Bromsgrove District and Redditch Borough Strategic Flood Risk Assessment

Level 1 Report – Summary of Changes

January 2009

Final Report

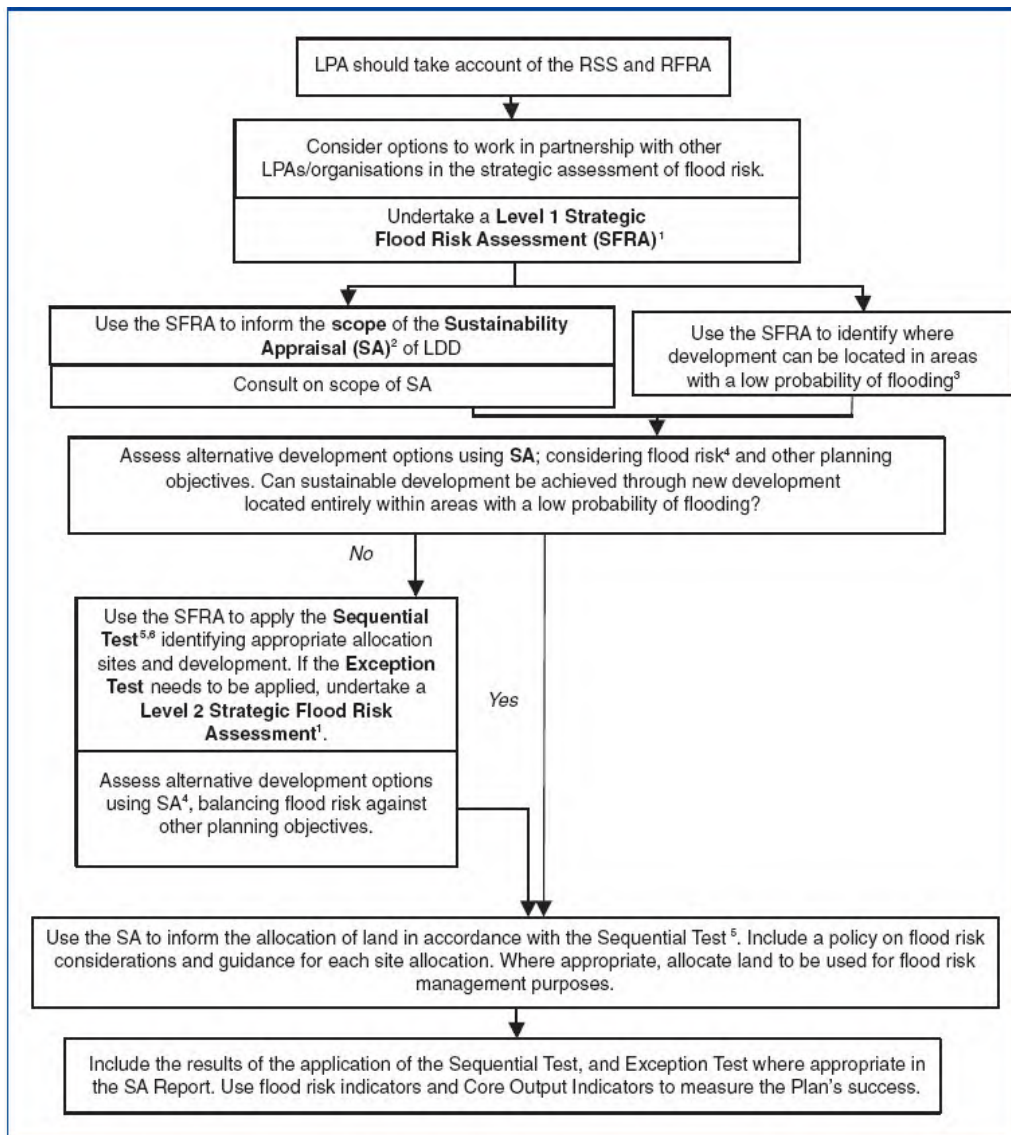
4.6.5 – Can we have something more specific in terms of guidance in reducing flood risk , there are a couple of issues that come from the Worcestershire Scrutiny Task Group on improvements to culverts and maintenance, however these were not detailed. Can these issues be taken forward to form recommended policies for new development i.e.

Any new development on a site should give full consideration to improving existing culverts by either opening them up or if this is not practicable then the existing culvert should be improved in capacity.

New developments that have watercourses running through them should have a comprehensive plan for managing and maintaining the watercourse.

Other ways of reducing flood risk is increasing flood storage, improving flood flow routes, removing existing obstructions to flow.

As a general comment I notice there isn't much in the Level 1 on recommended flood risk policies, is this going to be done at level 2.

Addition of section 5.2.2:

- *Any new development on a site should give full consideration to improving existing culverts by either opening them up, or if this is not practicable, then the existing culvert should be improved in capacity;*

- *New developments that have watercourses running through them should have a comprehensive plan for managing and maintaining the watercourse; and*
- *Where practicable flood risk should be reduced by increasing flood storage, improving flood flow routes and/or removing existing obstructions to flow.*
